FOOTHILLS WATER NETWORK

December 20, 2010

**RE: COMMENTS ON PLACER COUNTY WATER AGENCY'S
DRAFT LICENSE APPLICATION FOR THE MIDDLE FORK AMERICAN
HYDROELECTRIC PROJECT #2079**

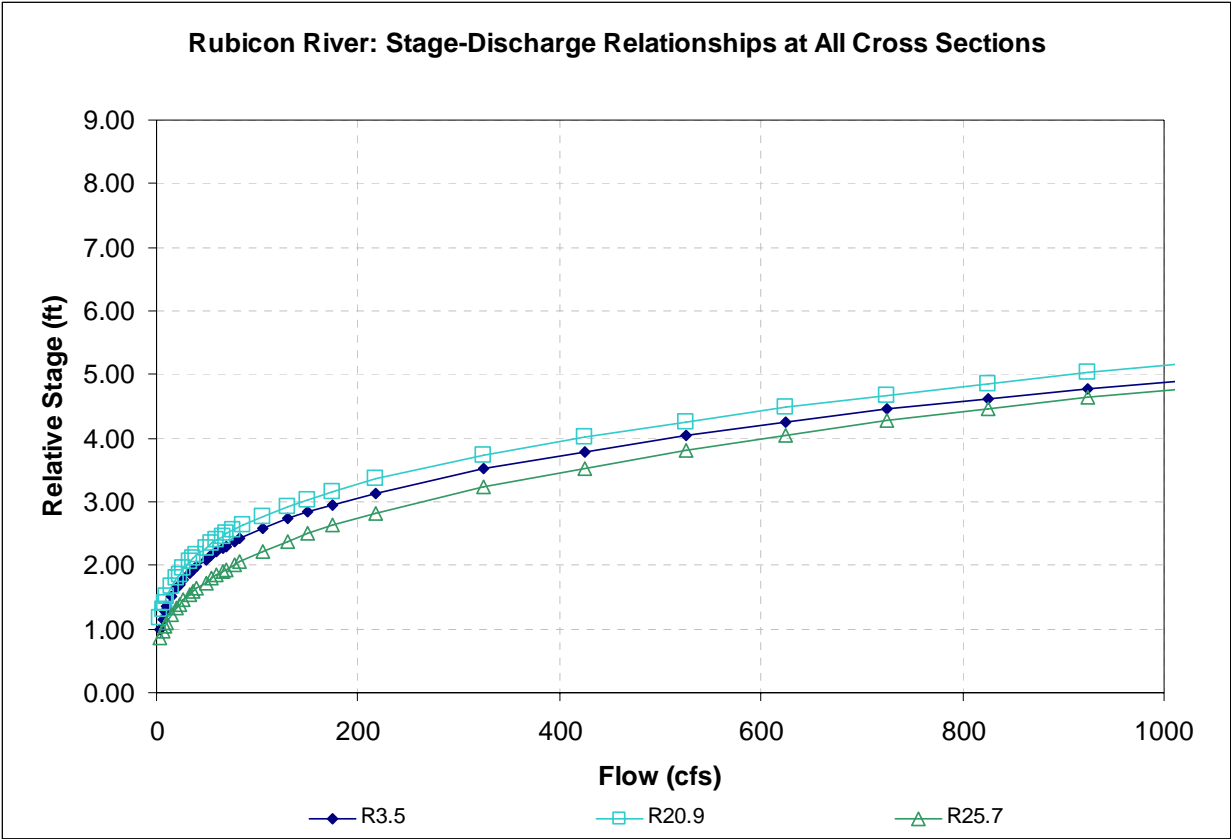
As we understand it, flows in the bypass reaches that inundate mid-channel bars could potentially trap and wash away juvenile Foothill Yellow-Legged Frogs. Therefore, maintaining flows below this inundation level is important for habitat retention in the fall period. We think that the stage change in the bypass reaches resulting from conveying minimum flows for the Peaking Reach would not inundate mid-channel bars. For example, if the Peaking Reach minimum flow during the outage is 200 cfs and each bypass reach conveys half of that flow, then the Rubicon River's minimum flows and additional 100 cfs would produce a stage change not exceeding 1.25 feet at river mile 20.9. We do not believe this incremental stage change would inundate mid-channel bars. See the Table 1 below for Stage Discharge Relationships for the Rubicon Resulting from Conveying Peaking Reach Minimum Flows During the Annual Maintenance Outage. Table 1 is based on Appendix B: PCWA's Rubicon River Stage Discharge Relationship at River Mile 20.9.

Figure O-15. Middle Fork American River MF14.1 Effective Food Production Habitat Matrix.

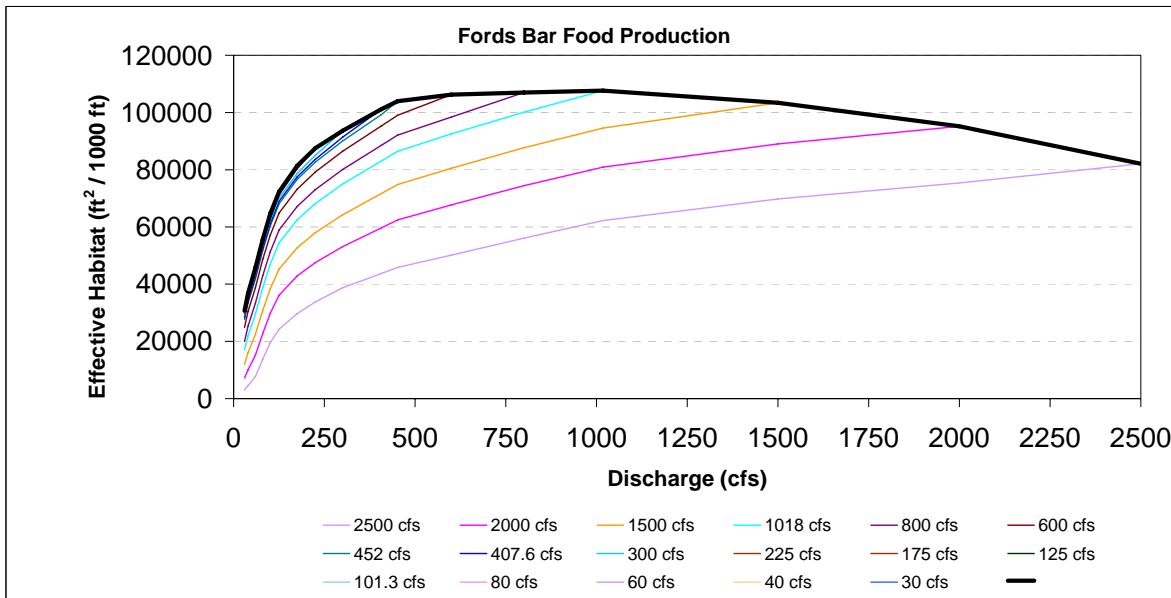
The Foothills Water Network recommends that PCWA include conditions in its FLA that reduce flow fluctuations in the Peaking Reach to increase benthic macroinvertebrates (BMI) populations and food production for fish. Based on PCWA's Effective Food Habitat Matrices for the Peaking Reach, food production increases as the magnitude of flow fluctuations decrease.¹⁰ (See Appendix C for AQ1-Instream Flow Study Report, Figure O-15 and O-24 Middle Fork American Effective Food Habitat Matrices.) An increase in minimum instream flows from the PCWA DLA proposed minimum flows would increase food production and BMI habitat in the Peaking Reach.
